Access Compliance Report Public Rights-of-Way (Curb Ramps)

Main Street: CHAPLET_PL Cross Street: KENNETH_DR Location: NW

ADA ID: RPRK220103154144 Ramp Type: Type 4 - Parallel Initial Pass/Fail: Pass Overall Compliance: No Severity Score: 0

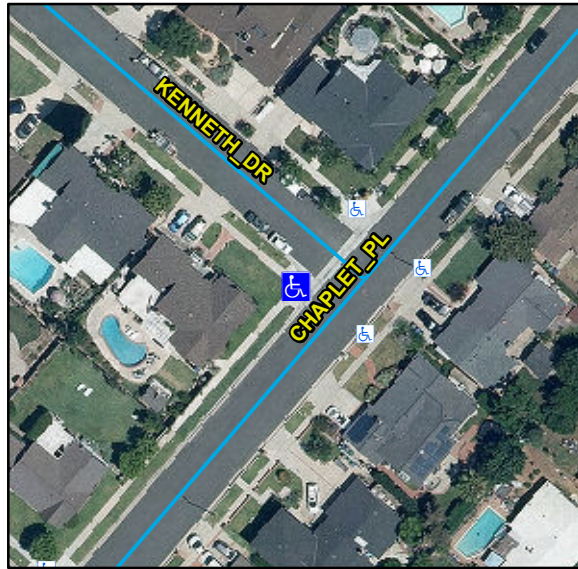
Gutter Ponding Observed.

N/A	Ramp Inside Crosswalk 1	N/A	N/A	Ramp Inside Crosswalk 2	N/A
	Crossing 1 Slope (%)	4.1		Crossing 2 Slope (%)	3.8
	Crossing 1 Cross Slope (%)	0.3		Crossing 2 Cross Slope (%)	2.2
No	Gutter Ponding	Yes	Yes	Curb Slope	3.2
Yes	Gutter Lip Height (in)	0		Road Run Slope (%)	1.3
Yes	Gutter Run Slope (%)	0.2		Road Cross Slope (%)	0.7
Yes	Gutter Cross Slope (%)	0.8	Yes	Perpendicular Joint Present	Yes
Yes	Overall Surface Condition	Acceptable			
	Cross Gutter Present?	Yes		Spandrel Present?	Yes
	Replace Cross Gutter?	No		Replace Spandrel?	No

R302.7, STD 1115
